# Access Compliance Report

## Public Rights-of-Way

Intersection ID: 24242	Main Street: BEVERLY_CREST_BV	Cross Street: PRESCOTT_POND_LN	Location: S
ADA ID: E982A6FA595B	Ramp Type: PerpDiag	Initial Pass/Fail: Fail	Overall Compliance: No
Severity Score: 13.75			
Codes/Mitigation Info/Possible Solution		Field Measurements/Component Compliance

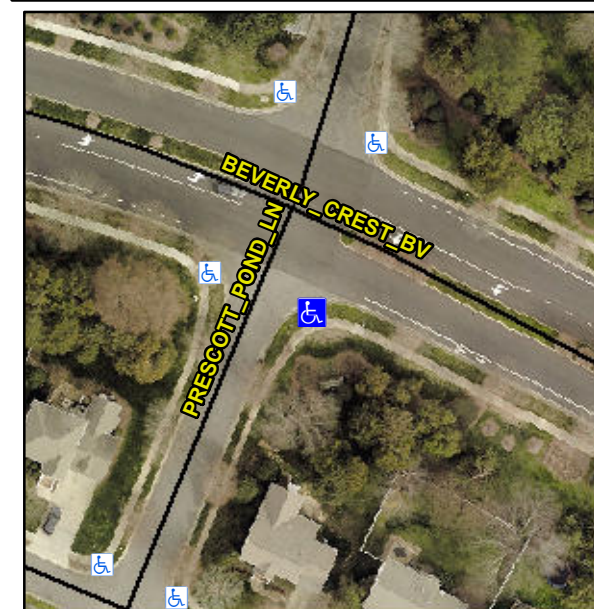
**Not Found, R304.2.2, R304.5.3**

Compliance	Description	Data	Compliance	Description	Data
N/A	Ramp Length (in)	96.0	No	Ramp Slope (%)	11.1
Yes	Ramp Width (in)	48.0	No	Ramp XSlope (%)	2.1
N/A	Flare Type LT	N/A	N/A	Flare Type RT	N/A
N/A	Flare Slope LT (%)	N/A	N/A	Flare Slope RT (%)	N/A
N/A	Flare Traversable LT?	N/A	N/A	Flare Traversable RT?	N/A
N/A	Landing Length (in)	N/A	N/A	DWS Provided?	N/A
N/A	Landing Width (in)	N/A	N/A	DWS Contrast?	N/A
N/A	Landing Slope (%)	N/A	N/A	DWS Length (in)	N/A
N/A	Landing X Slope (%)	N/A	N/A	DWS Full Width?	N/A
N/A	Landing Curb? (Y/N)	N/A	N/A	DWS Offset (in)	N/A
N/A	Shared Landing?	N/A			
N/A	Gutter Ponding?	N/A	N/A	Gutter Slope (%)	N/A
N/A	Gutter Lip Ht (in)	N/A	N/A	Gutter X Slope (%)	N/A
N/A	Painted X Walk1?	No	N/A	Painted X Walk2?	No
	X Walk 1 Direction	To NE		X Walk 2 Direction	To NW
N/A	X Walk 1 Width (in)	N/A	N/A	X Walk 2 Width (in)	N/A
	X Walk 1 Slope (%)	0.5		X Walk 2 Slope (%)	3.5
	X Walk 1 X Slope (%)	3.2		X Walk 2 X Slope (%)	0.7

**Remove & Replace Curb Ramp With Two New Directional Ramps or Equivalent.**
